## ADDENDUM TO THE CONTRACT

### JNU SREF Site Infrastructure

Contract No. E12-280

**ADDENDUM NO.:** ONE

C-005

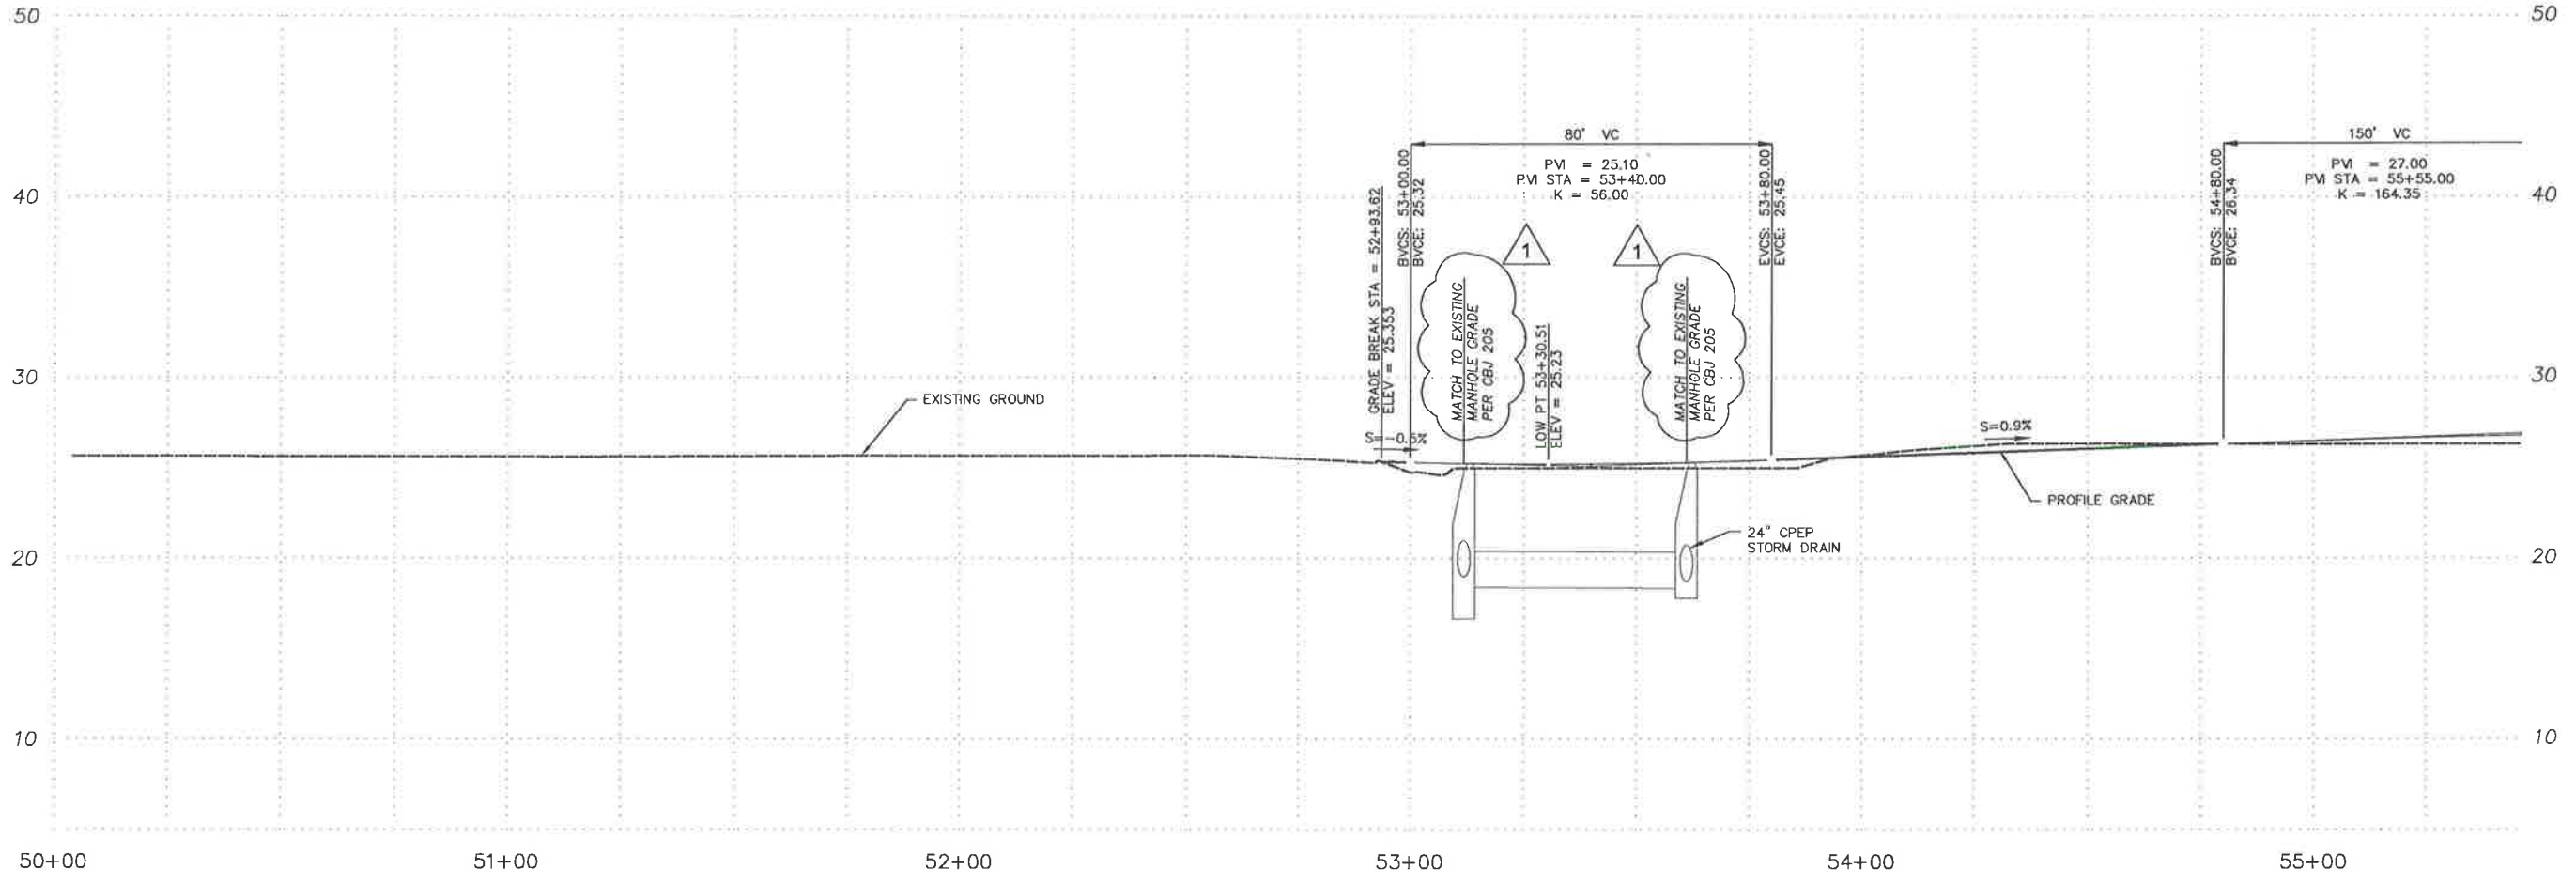
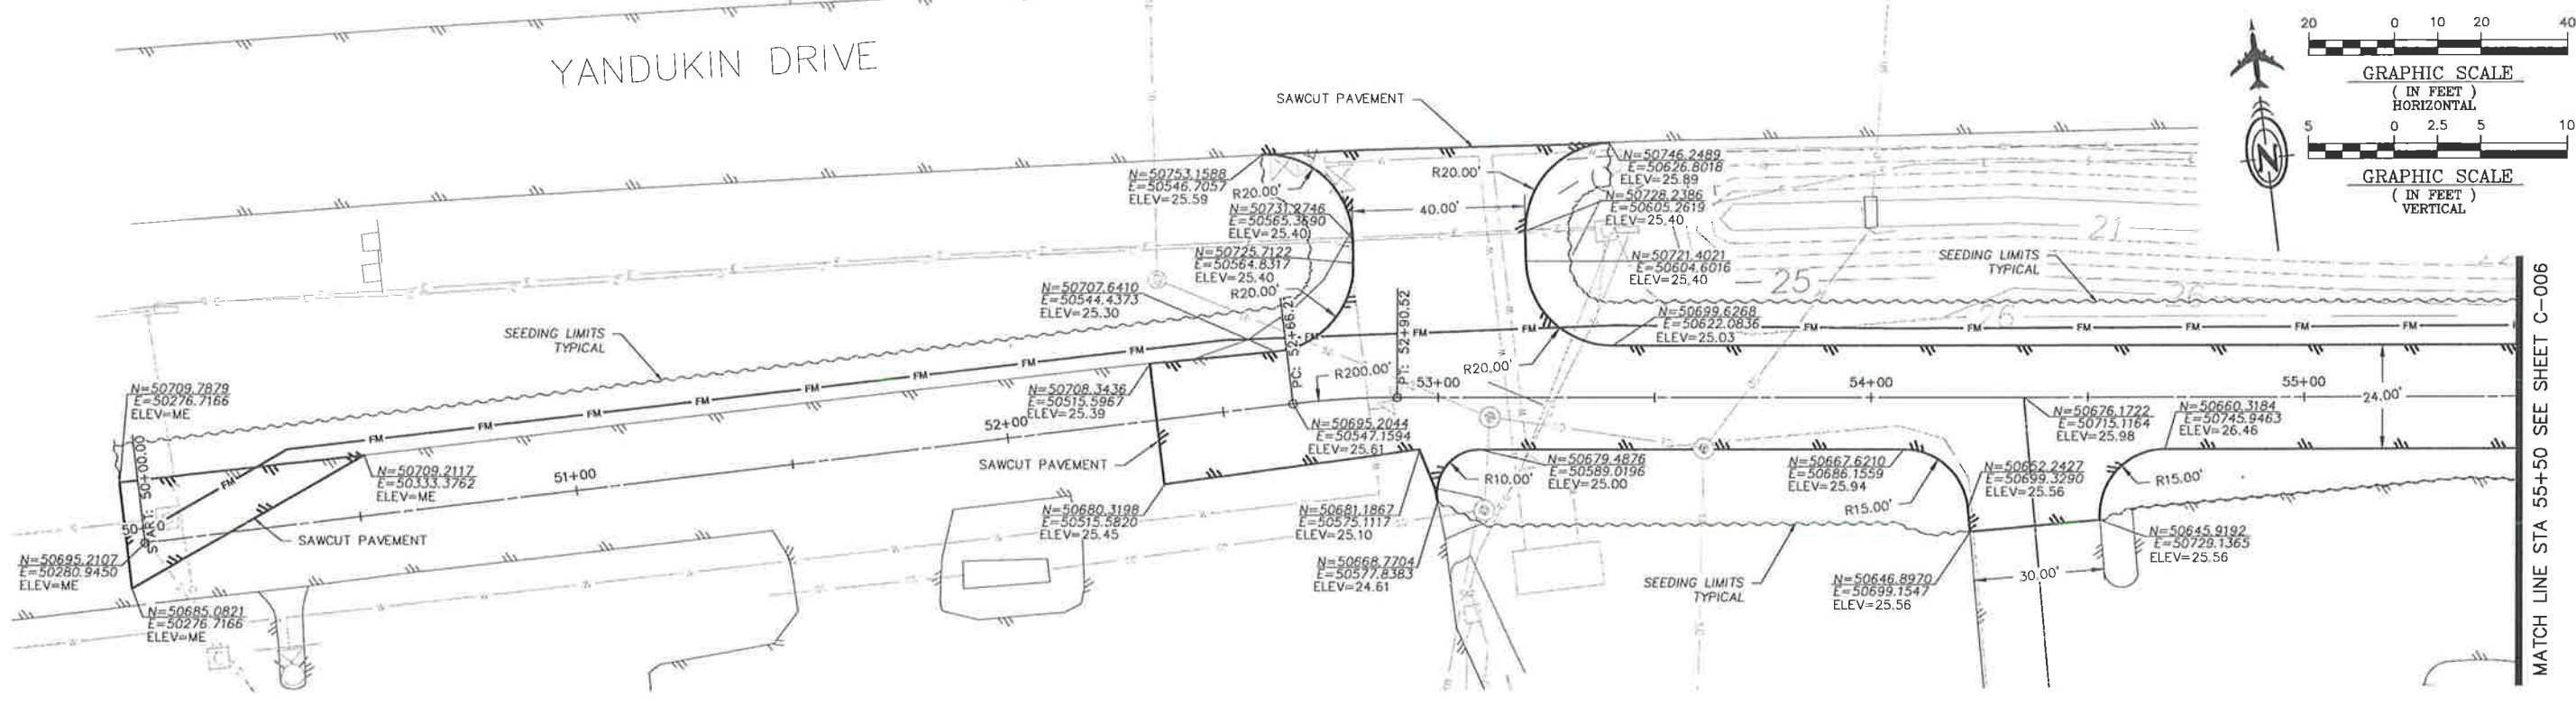
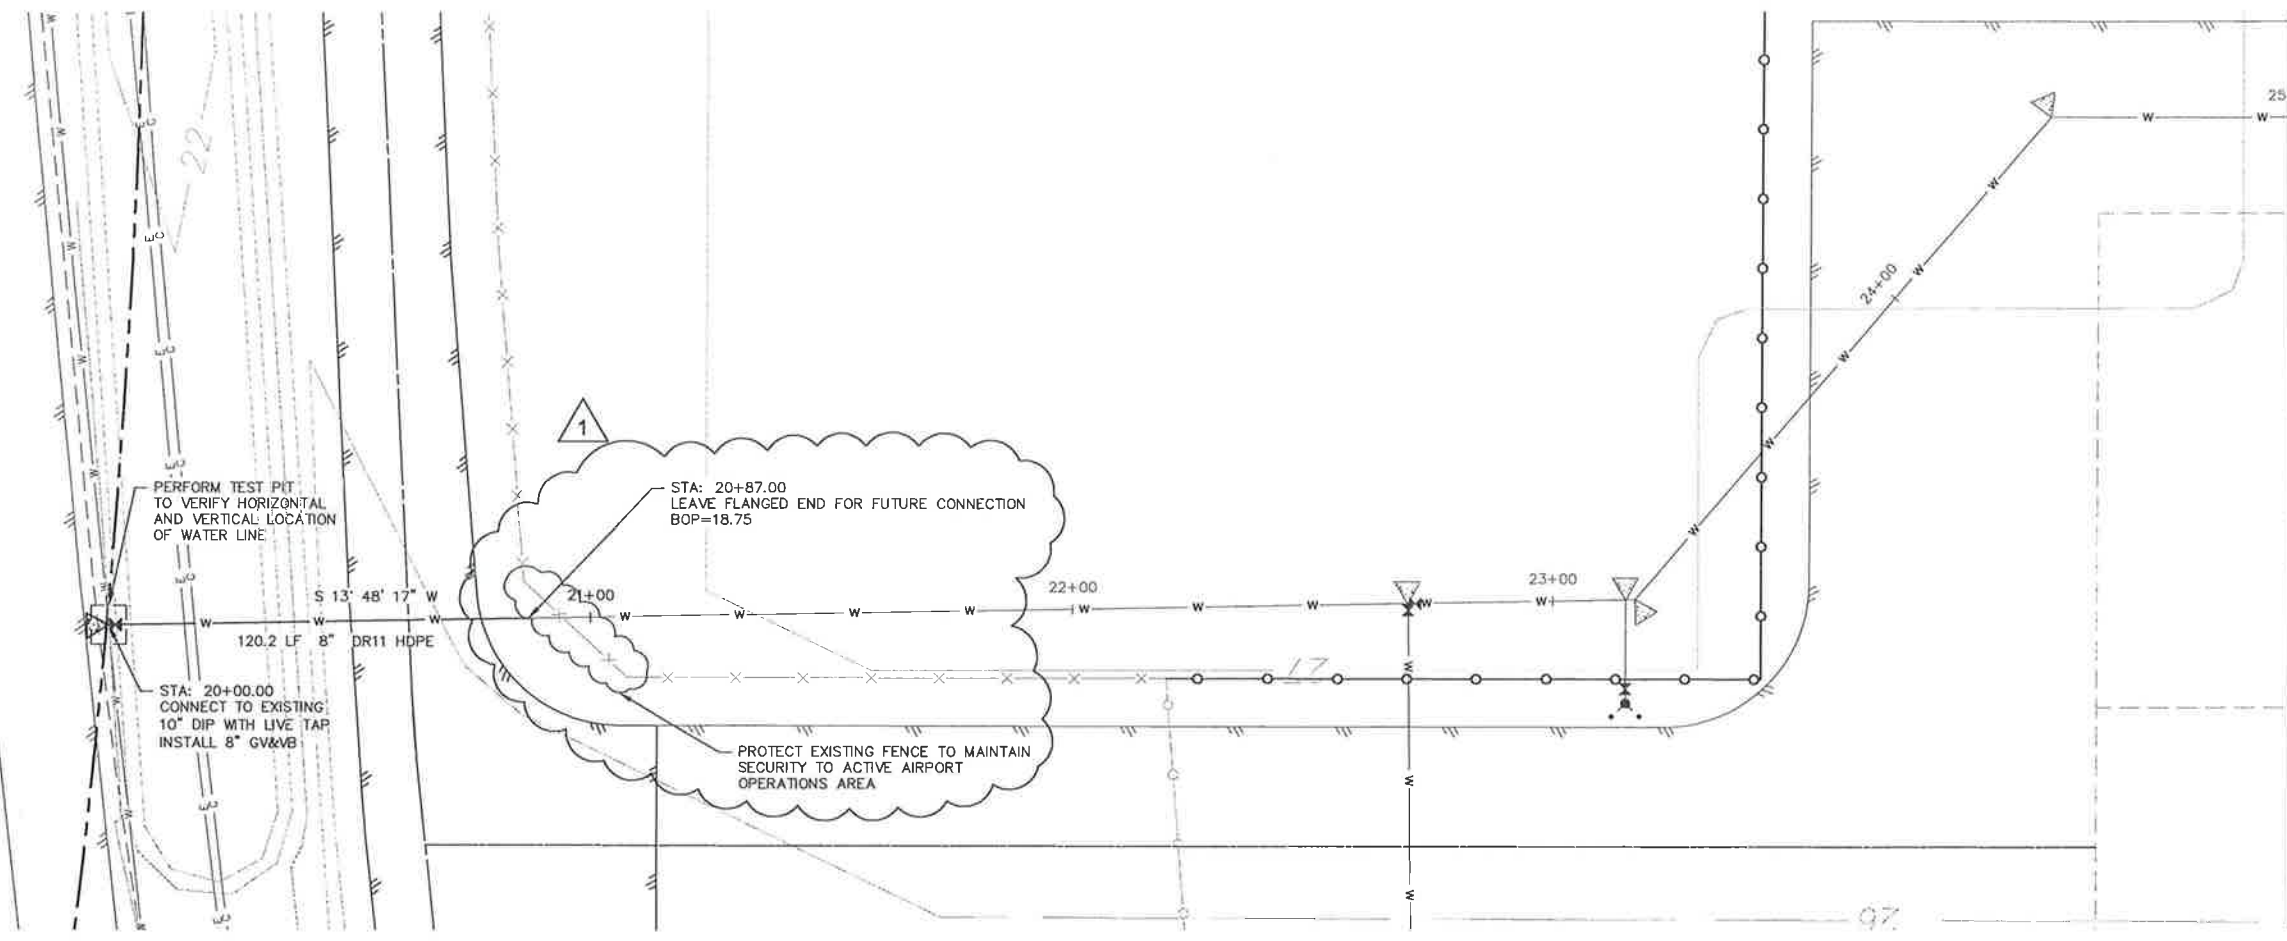
- Item No. 4: Drawing C-005, titled “Frontage Road Plan & Profile”, **replace** with the attached sheet : C-005, titled “Frontage Road Plan & Profile” Addendum 1  
Principal Changes:  
➤ Added notes to Profile that Pavement shall be field adjusted to match Storm Drain Manholes grade per CBJ Standard Detail 205
